***Commercial Office Building  
Site 8A Murray Rose Avenue  
Sydney Olympic Park***

**MP 06\_0175 (MOD 2)**

Modification of Minister's Approval under section 75W  
of the *Environmental Planning and Assessment Act*  
1979

April 2009

Figure 2. SOPA On-street Traffic Plan

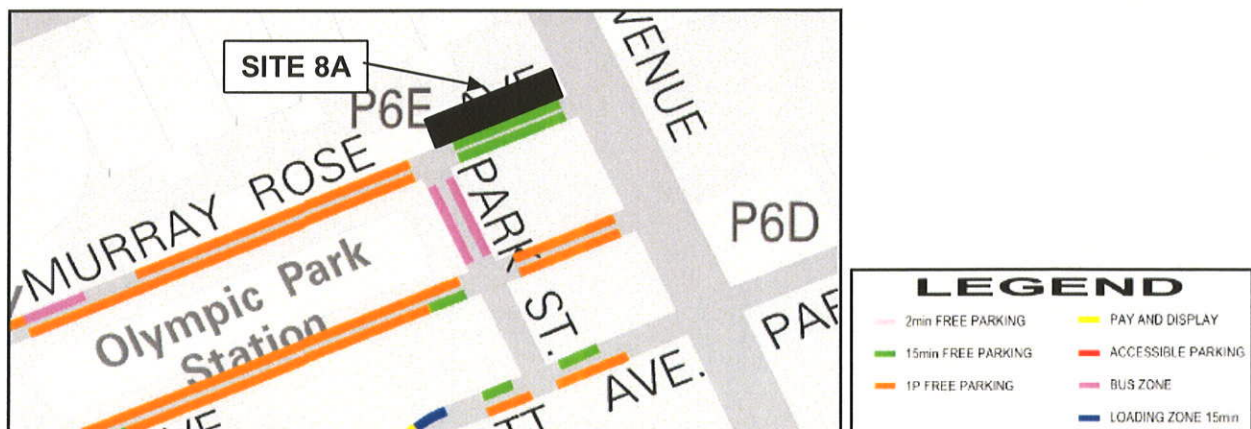
The Proponent has also stated that the dedicated loading zone would be supplemented with loading potential on Murray Rose Avenue through short term parking options being reviewed for Murray Rose Avenue by SOPA (**TAG G**). SOPA have confirmed that on-street traffic plan includes 15 minute parking on Murray Rose Avenue adjacent to the site as shown in the figure below.

The Department recognises that smaller vehicles would be inclined to utilise short term parking spaces that are now available along Murray Rose Avenue given the convenience and that the internal loading area will require secured access entry, and access to the retail tenancies is hindered by stair access and lack of direct access to one tenancy. Larger vehicles would use the loading zone on the service lane, which has been approved by SOPA (see **TAG H**). Smaller vehicles would also have equal access to the 24 metre loading zone on the service lane if the parking spaces along Murray Rose Avenue were unavailable. Subsequently, the internal loading area will become redundant. Accordingly, the modification sought to delete the internal loading area is considered acceptable given there will be a 24 metre loading zone on the service lane.

The Department notes that the Proponent has not addressed loading arrangements for the site when access to the service lane is restricted. The Department recommends that loading arrangements be detailed in the Parking Management Plan required in Condition F13 and recommends amending this condition to include the following:

- (8) The Parking Management Plan shall identify the loading arrangements that will be implemented during the Easter Show Special Events period when there will be no access to the service lane and loading zone. The arrangements shall address garbage collection measures and all loading activities.**
